**CHARTER TOWNSHIP OF VAN BUREN
PLANNING COMMISSION AGENDA
Wednesday, April 26, 2017 – 7:30 PM, Board of Trustees Room**

**Subject: VBT-16-037 SPR; Speedway at Belleville Road and Tyler Road; Site Plan Review #2;
Revised Plans Dated April 13, 2017**

RE: VBT 16-037-SPR, Speedway, Belleville Road and Tyler Road
Site Plan Review #1

Re: Speedway
Preliminary Site Plan Approval

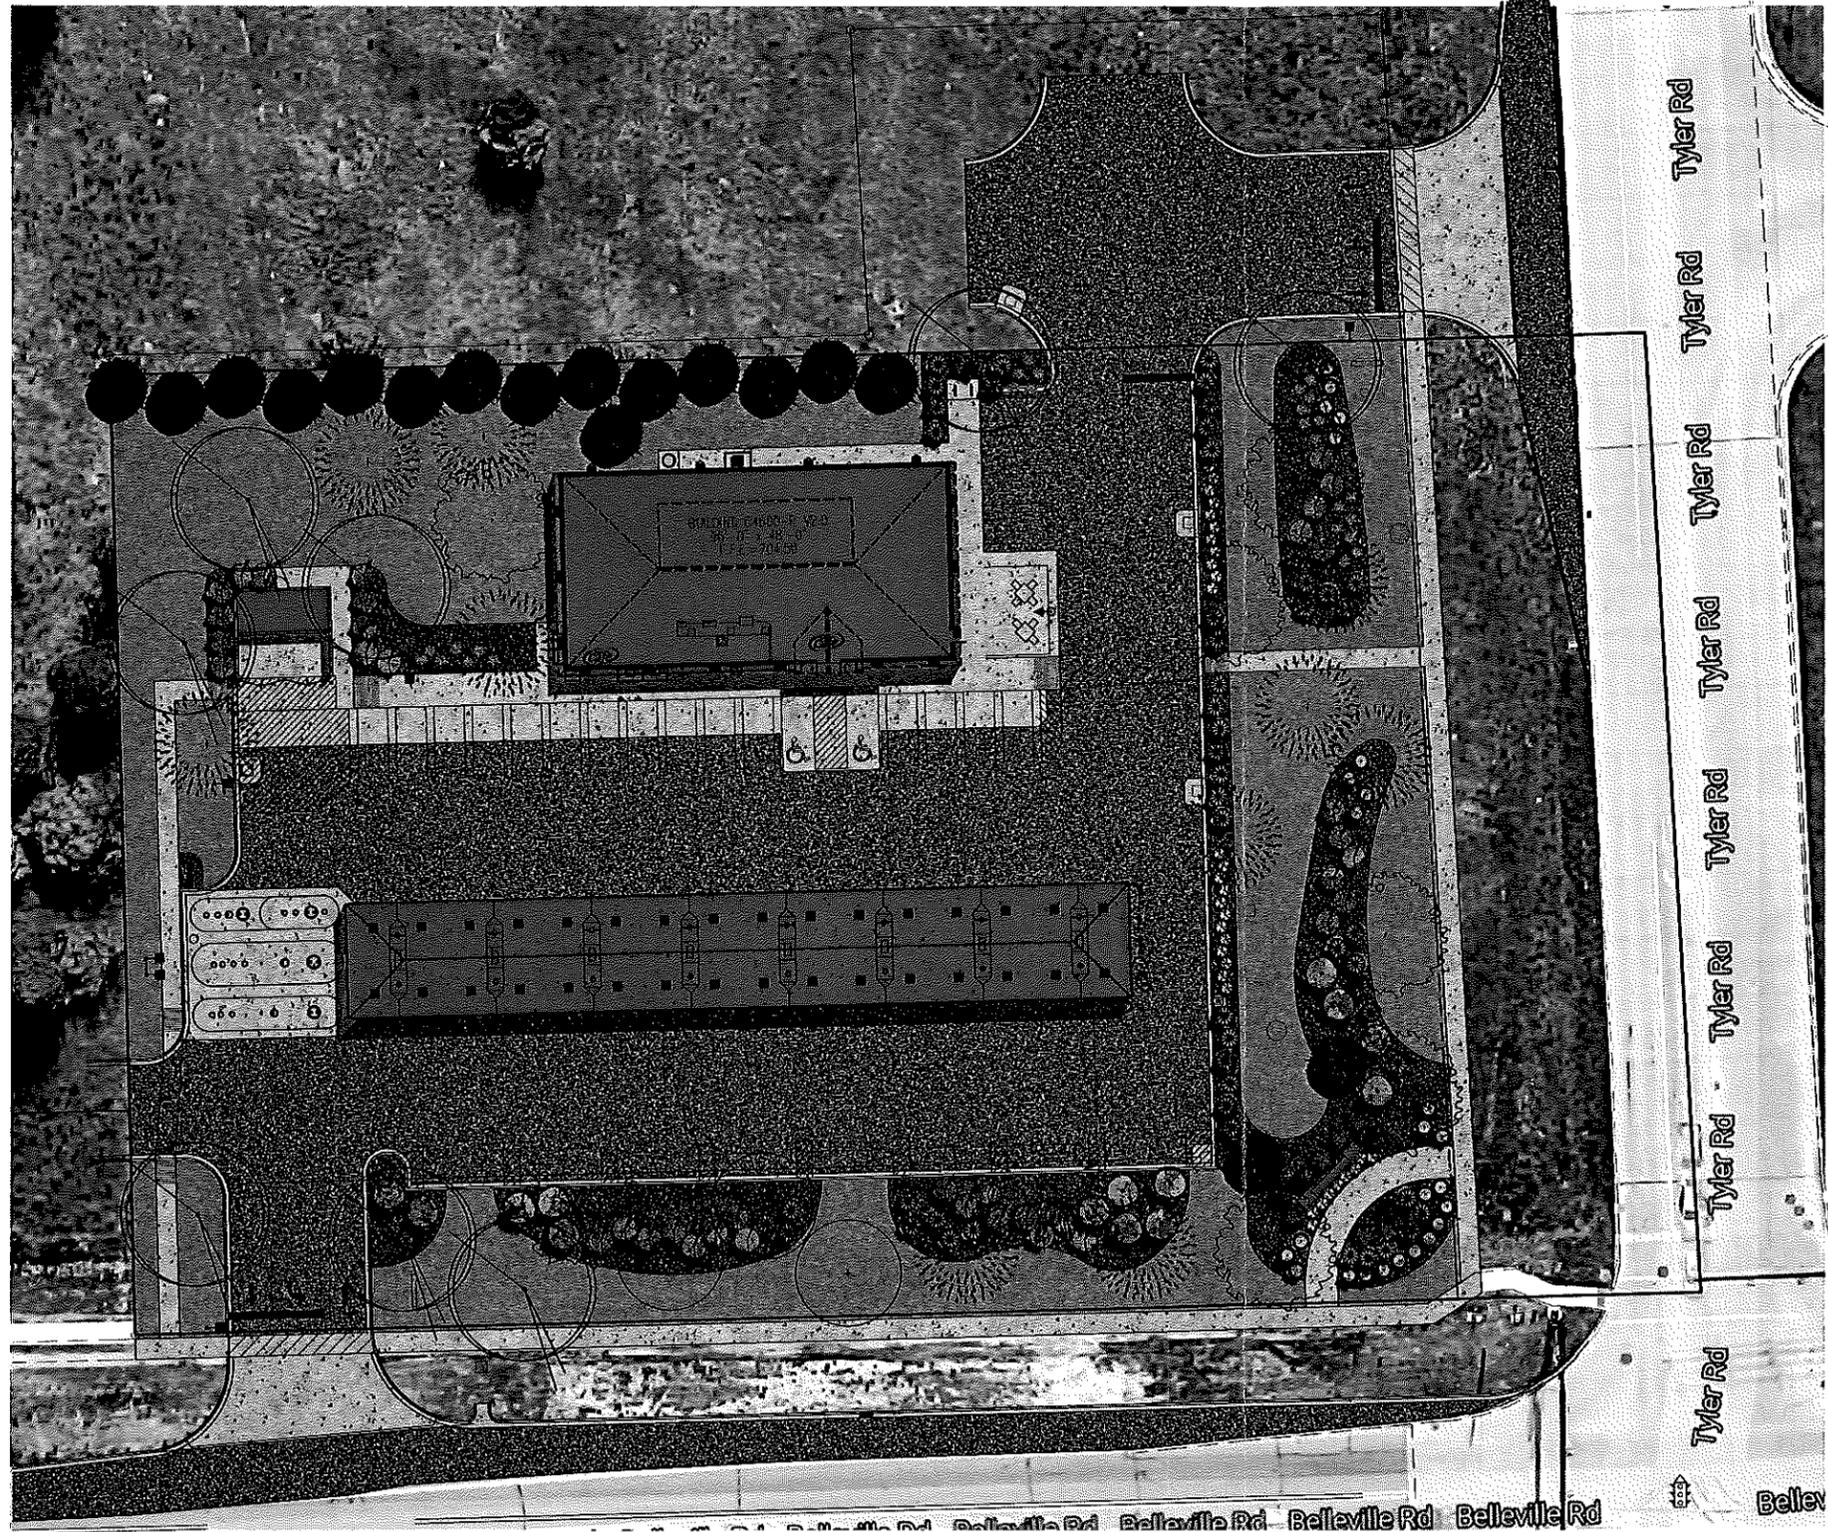
For reference, please see Figures 1 and 2 which show the front (west facing) and left side (north facing) elevations of the proposed canopy, respectively. These are for comparison with to Figures 3 and 4, which show the same elevations of the typical Speedway canopy design.

Respectfully, we find that our proposed design is superior to the examples identified in the McKenna letter. As shown by the street view images of Examples 1 and 3, a rear facing building results in the back of the building being the most visible area to the intersection. We find this visually unappealing, as the back of the building does not allow for transparent windows, as illustrated by Example 3, and must accommodate utilitarian components such as an HVAC unit and air vents.
